# PUBLIC UTILITY COMMISSION OF OREGON STAFF REPORT PUBLIC MEETING DATE: June 16, 2020

(Docket No. UM 2056)

Recommendation on acceptance of Pacific Power's Transportation

Electrification Plan.

Projected Number of EVs in Pacific Power's Territory Through 2025
The Plan included the Company's first forecast of EVs in its Oregon service territory.

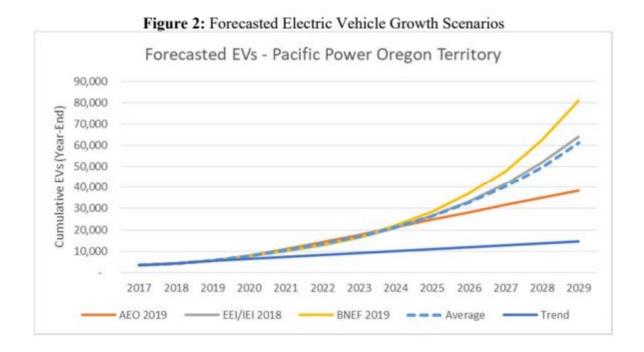
Staff sought a comparison of the forecast method with historical numbers from 2017 to 2018 in order to determine if the averages of past forecasts overestimated, or underestimated, the Company's known annual EV counts.

All forecasts grow at a higher rate than an extrapolated trend of what has been observed in Pacific Power's service territory in recent years. This suggests the Company's forecast may overestimate EV adoption by Pacific Power's customers, a problem that can be further addressed in the next integrated resource plan and distribution system plan.

In Figure 2, the Company replied with a trend analysis utilizing actuals from 2016 to 2019:<sup>11</sup>
